Planning Ref: SD22A/0286

RE: ADDITIONAL INFORMATION Submission with respect to Planning Reference SD22A/0286 – Deane & Deane Ltd, - PERMISSION for the demolition of 2 no. sheds and the construction of 30 no. dwellings, at Main Street, Newcastle, Co. Dublin.

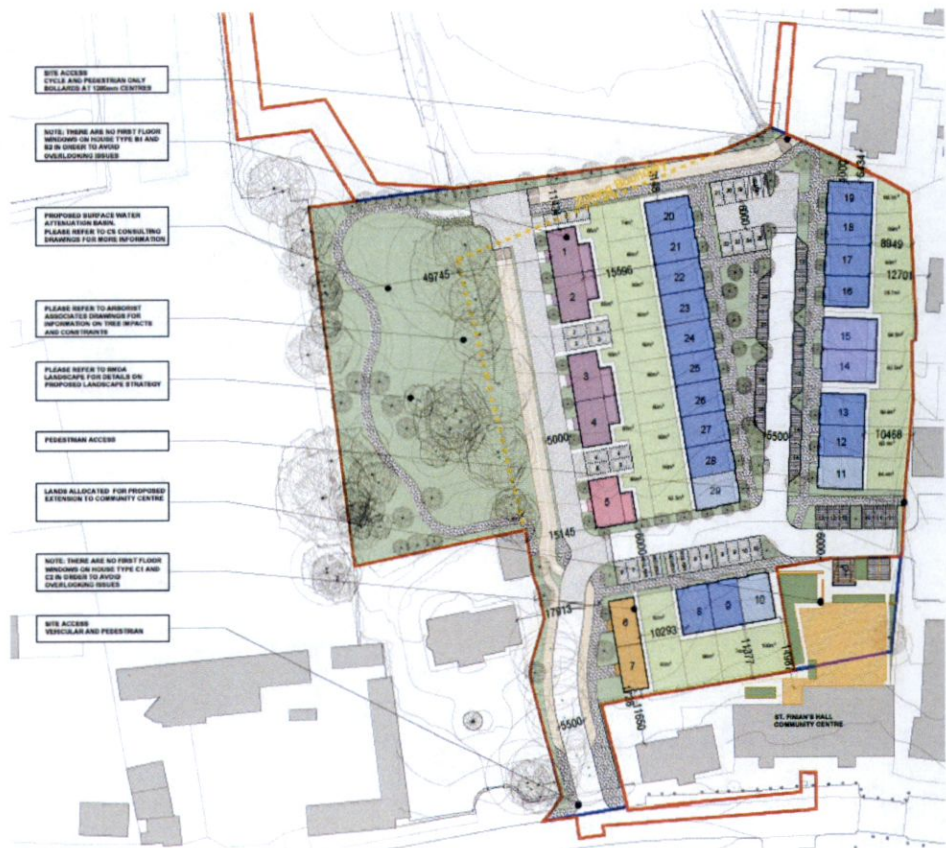
Item 1 d). demonstrate compliance with Section 8.7.3: and

Details of compliance with the overall standard and the standard for new residential development on lands zoned RES-N are provided above under part b) and c). The remaining two standards in Table 8.2 are not applicable to the subject proposal.

Fig 6.24 Overall Framework for Plan Lands

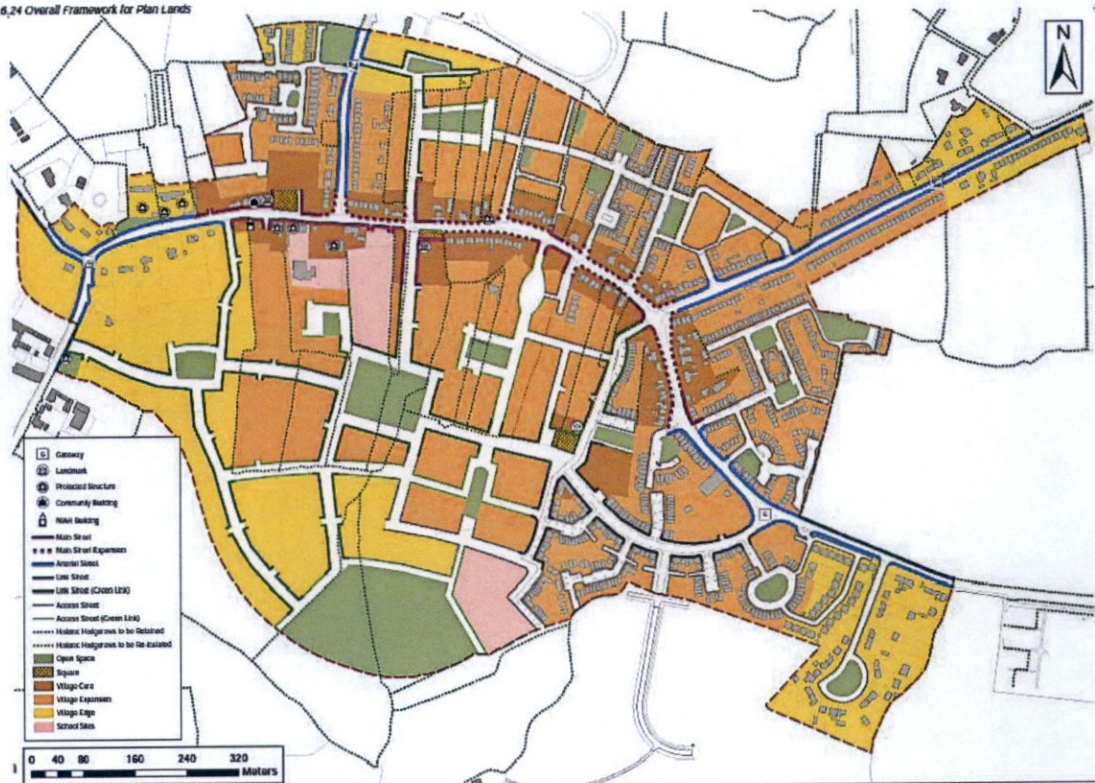
- a) It is noted that Objective PN6 of the LAP requires the provision of a connection between the rear of St. Finian's Hall (community centre) with Newcastle Glebe in the form of an 'extended vehicular cul-de-sac'. The proposed development provides for a vehicular connection from the subject site to Newcastle Glebe as required by the objective. It is noted that the objective refers to an extended vehicular cul de sac. Vehicular permeability to the Main Street from the Glebe is provided and as such, a cul de sac arrangement is not provided. The applicant is requested to provide an extended vehicular cul de sac arrangement with the Glebe in accordance with Objective PN6 of the LAP. This is likely to require omission of vehicular connection to the Main Street.

- a) While it is acknowledged that the Newcastle LAP (NLAP) contains an objective to provide a cul-de-sac within the application site, it is submitted that the NLAP was first implemented in 2012. While the NLAP has been extended until December 2022, many of the objectives contained within it are outdated and not in line with the most recent guidance, such as DMURS in this instance.

Cul-de-sac arrangements are discouraged in DMURS and therefore it is considered appropriate to retain the vehicular connection through to the Main Street as provided for in the application. The connection through to Main Street will improve permeability and access to the proposed

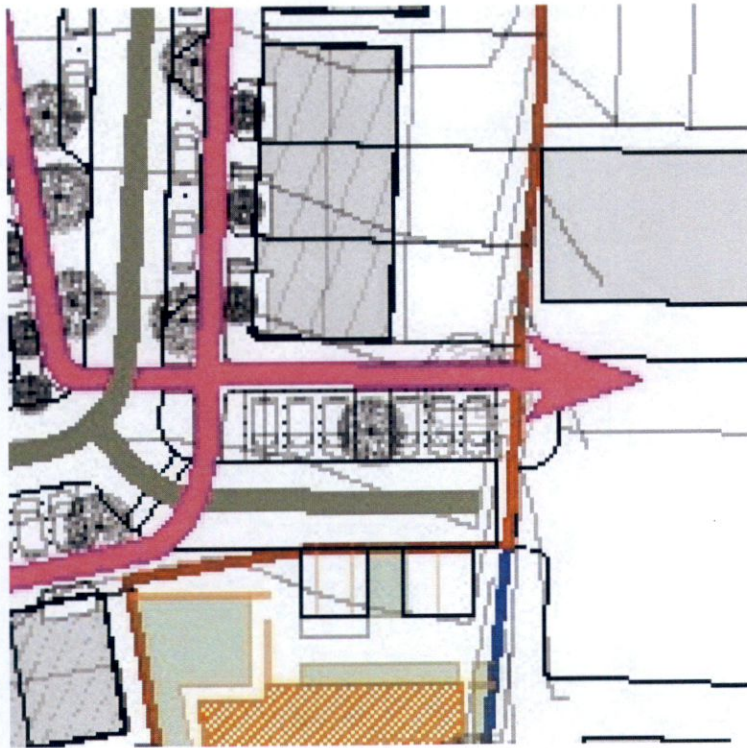
- b) Concerns are raised in relation to the implementation of the vehicular connection to the Glebe and sufficient legal interest. The street in Newcastle Glebe appears to be Taking in Charge, however, third parties have questioned same. The applicant is required to clarify that sufficient legal interest and relevant consents are in place.

- b) It is submitted that the street in Newcastle Glebe is taken in charge and consent was received from SDCC. Please refer to the SDCC Taken in Charge Map and Letter of Consent submitted with planning application documents
- c) A potential future connection is indicated in the application, to the extent of the applicant's ability. Therefore, the objective has been facilitated and has not been hindered by the application. It is clear from documentation provided with the application that there is no proposal to provide a physical connection as part of this planning application, as the land required for such connection is not within the applicant's ownership. Please see extract from the Architectural Design Statement and the Site Permeability Plan prepared by JFOC and submitted with the planning application below indicating a 'potential future pedestrian link' to the east.
